## ***Interactive comment on “Flood frequency analysis of historical flood data under stationary and non-stationary modelling” by M. J. Machado et al.***

**M. J. Machado et al.**

Received and published: 10 March 2015

Fig. 1.

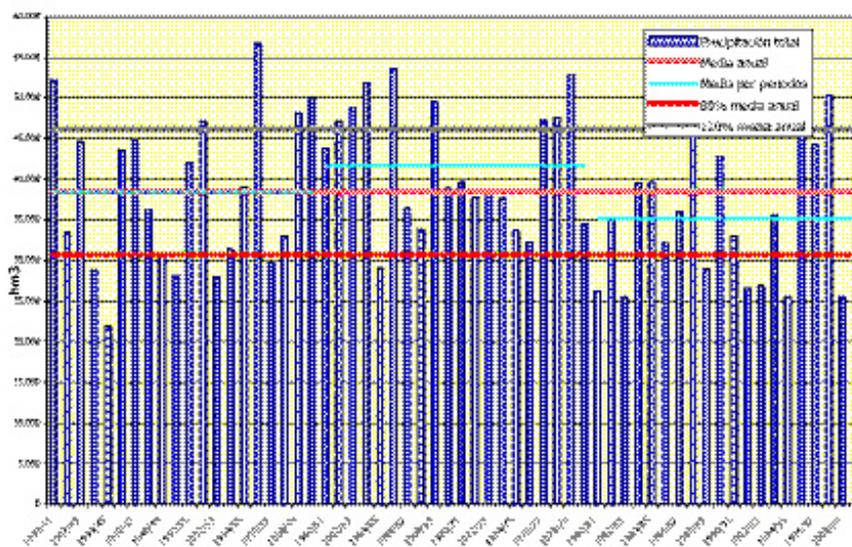
4.- On the following comment: “As usual, the discharge time series are flagellated by human activities. Authors underlines that there is an abrupt changes in 1957 for the dam constructions, however I think their influence (statistically speaking) should be related to several years (i.e. 1952, 1953, 1954, 1955, show very low values). If I am not wrong we are talking about reservoirs of several cubic kilometers that affects 80% of the watershed. From the beginning of the construction to the end there are surely some effects on the discharges. Furthermore, the dam operations, at the beginning of the dam life, surely influences data. Maybe contemporaneously rainfall data would have been helpful for understanding what happened in these years as well as the

reconstruction of natural discharge could be also useful.”

Response: In our record at Aranjuez, low annual peak floods in that decade start on 1953 (62 m<sup>3</sup>s<sup>-1</sup>), 1954 (59 m<sup>3</sup>s<sup>-1</sup>), 1955 (64 m<sup>3</sup>s<sup>-1</sup>), and 1955 (97 m<sup>3</sup>s<sup>-1</sup>). However, it would be difficult to link these low discharge values to the dam construction itself because there are historical precedents of a sequence of years with low discharges due to droughts. In fact, during the previous decade to the starting dam operation, the rainfall in the whole Tagus catchment (see below figure) as well as the runoff produced upstream of the reservoir, were lower than average due to drought conditions. In addition, we don't think that adding these years to the dam regulation will produce any major change in our results, and we rather prefer to stay with the year of starting dam operations (1957) in the application of the Reservoir Index.

See attached Figure 1. Total rainfall in the Tagus River Basin in hm<sup>3</sup>. Source: Water Authority of the Tagus River Basin.

Fig. 3.

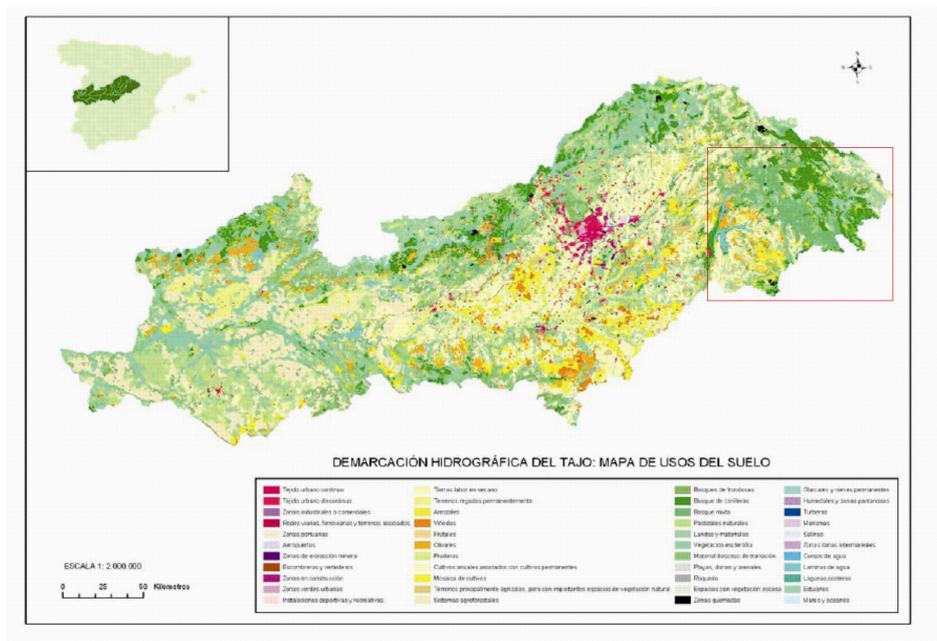
5.- Regarding the last comment “Finally, I kindly disagree with the authors when they say (page 540 - lines 7-11) that the land use changes are out of scope of the paper. In my opinion, this is one of the most important reasons of non-stationarity in a discharge time series that usually is much more relevant than a potential climate change (hydrological change, in my opinion, is more impacting than the climate change). Maybe this watershed is not affected, however, it is important to support it showing land use maps of the past comparing it to the present ones.”

Response: Our text in the paper it was not intended to diminish the importance of land use changes on catchment hydrology, but to indicate that we cannot cover in our paper all the aspects influencing flood peaks. Moreover, including several maps with land use and cover changes in this paper will make it more difficult to read and it is not

going to provide further insight into our methodological analysis. As indicated in the paper, the area upstream of the reservoirs corresponds to forest and shrubs and the population density has been historically very low. In a general map (next figure) we have marked in a red rectangle the area upstream of the reservoir sites, and it shows in green colours the cover by forest and shrubs, typical of a mountain region. In any case, we will improve this sentence in the final manuscript.

See attached Figure 3. Land use of the Tagus River Basin. The red rectangle shows the area upstream of the study reach, which is dominated by green colour corresponding to forest and shrubs. Source Tagus River Basin Authority.
